*KIRK<sup>®</sup> Release Notes*

KIRK<sup>®</sup> 6020, KIRK<sup>®</sup> 6040

KIRK<sup>®</sup> 7010, KIRK<sup>®</sup> 7020 and KIRK<sup>®</sup> 7040

**Firmware Version** PCS 09Ha  
Q4, 2011

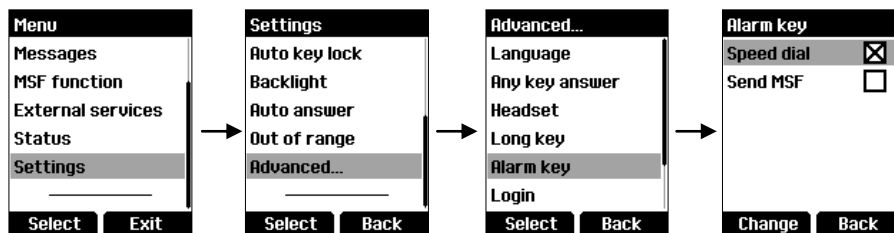
- Added support for broadcast messaging. The messaging format now includes icons.
- During an active voice call, the alert tones of received messages are attenuated by 30dB.
- The speaker gain, when in loudspeaking mode, has been raised by 12dB.
- Ringer tone 2 has been replaced by a low-frequency higher volume “digital” ringer tone.
- Ringer tone 3 has been replaced by a high-frequency higher volume “digital” ringer tone.
- The built-in wired headset amplifier<sup>1</sup> can be configured using the handset menu, see screen dumps below. The selectable amplification range spans from -12dB to +18dB.

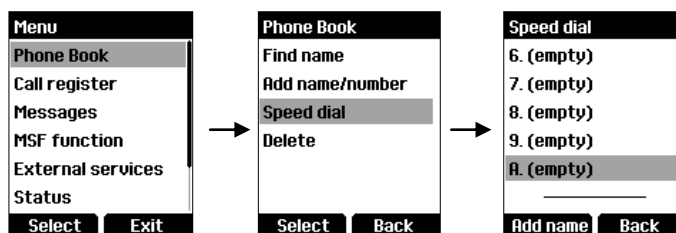
- An entry in the phone book can be assigned to a long key press on the alarm key. First the alarm key must be configured to use speed dial, see below.

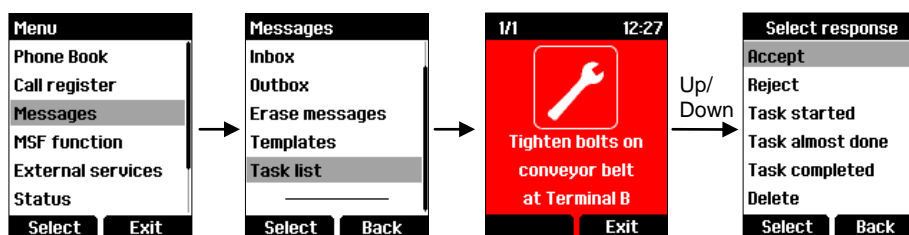
Then speed dial entry “A” must be assigned by selecting Add name:
